DASSAULT AVIATION
SERVICE BULLETIN :

F900-368

TITLE: **NAVIGATION - ATC - ATC REPLY INHIBIT ON GROUND**

F900-368

- FIGURE 1 -

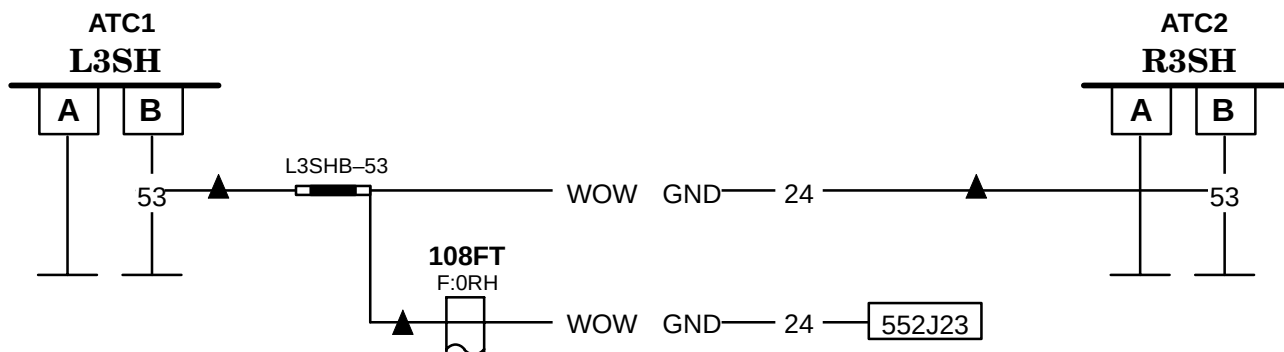
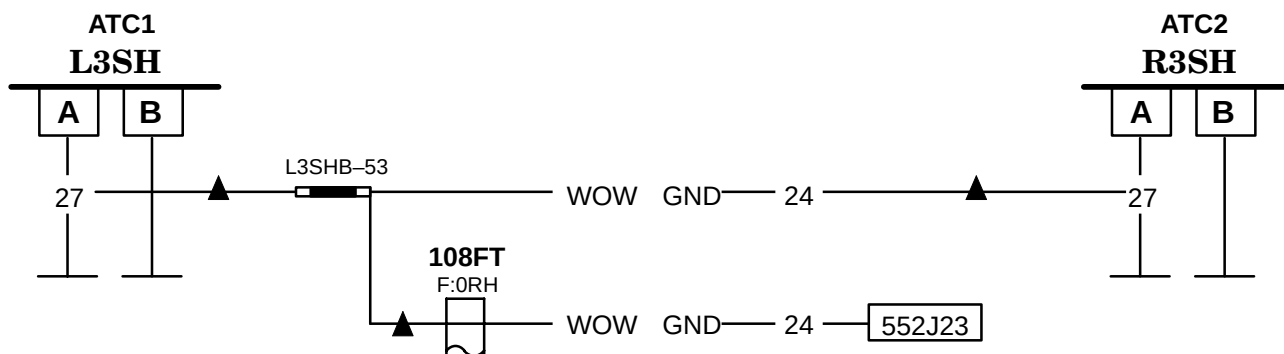
- (1) Remove ATC 1 (L3SH) and ATC 2 (R3SH) (IPC, chap. 34-50-40, fig. 11, item 40. Gain access to the wiring connected to connectors (L3SHA), (L3SHB), (R3SHA) and (R3SHB).
- (2) Make the electrical modifications in accordance with the diagram in figure 1.

NOTE: On each ATC, disconnect #24 gauge wires from terminal 53 of connectors (L3SHB) and (R3SHB) and reconnect them to terminal 27 of connectors (L3SHA) and (R3SHA).

CHANGE TO WIRING DIAGRAM MANUAL: 34-52-01
34-52-51

- FIGURE 2 -

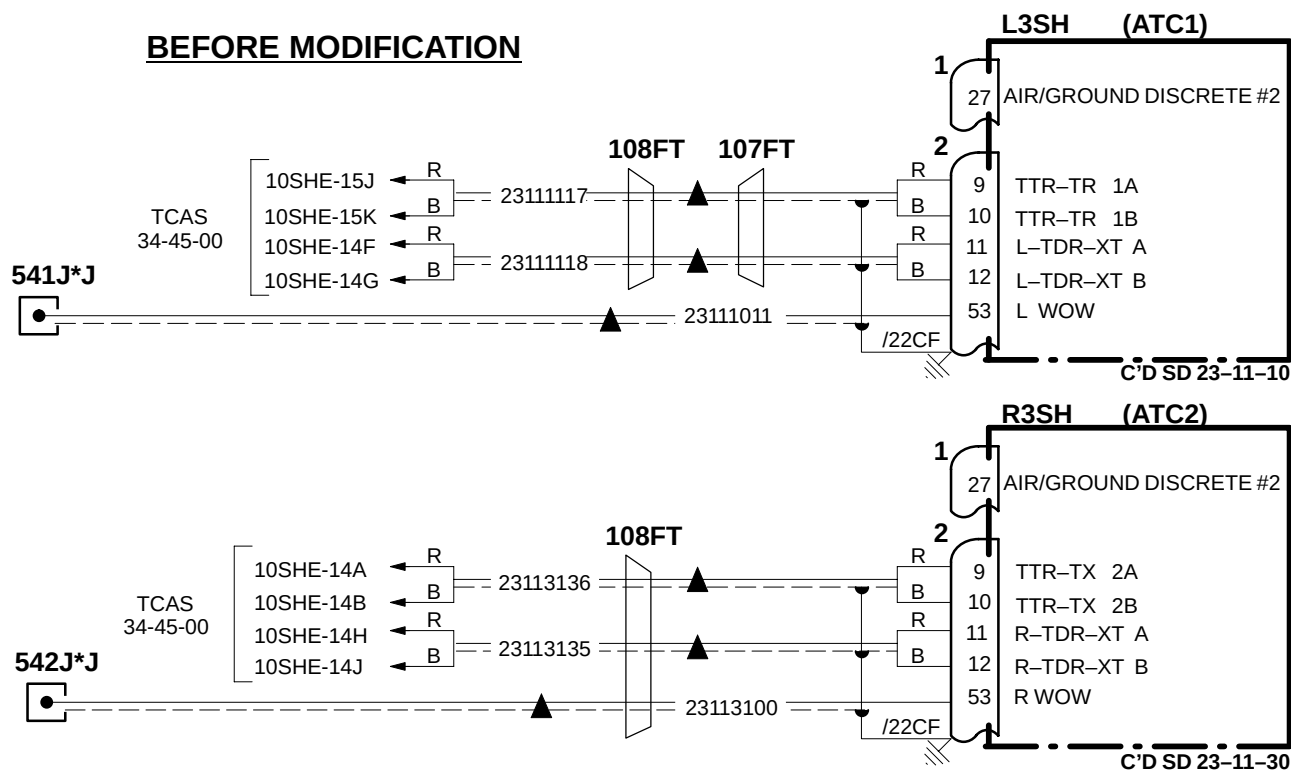
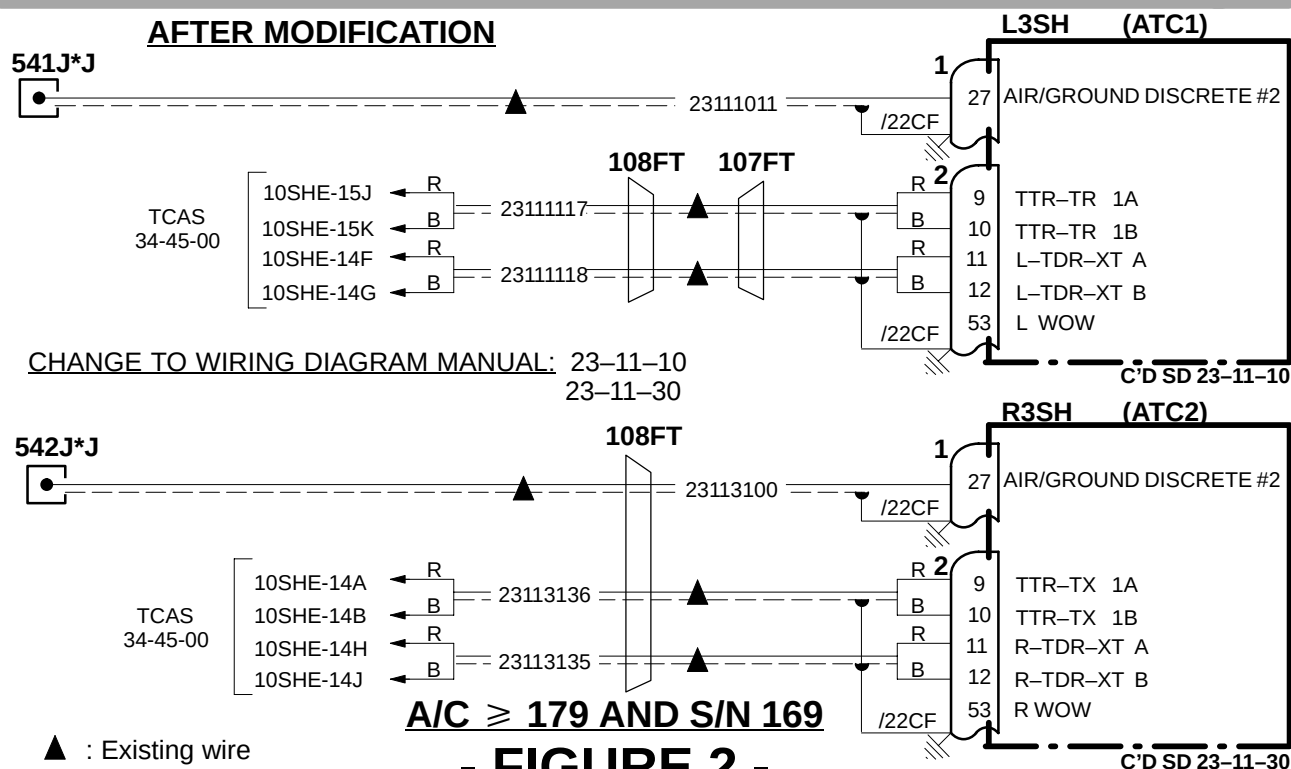
- (1) Remove ATC 1 (L3SH) and ATC 2 (R3SH) (IPC, chap. 34-50-40, fig. 11, item 40. Gain access to the wiring connected to connectors (L3SH1), (L3SH2), (R3SH1) and (R3SH2).
- (2) Make the electrical modifications in accordance with the diagram in figure 2.

NOTE: Disconnect wire 23111011 from terminal 53 of connector (L3SH2) and reconnect it to terminal 27 of connector (L3SH1).
Disconnect wire 23113100 from terminal 53 of connector (R3SH2) and reconnect it to terminal 27 of connector (R3SH1).
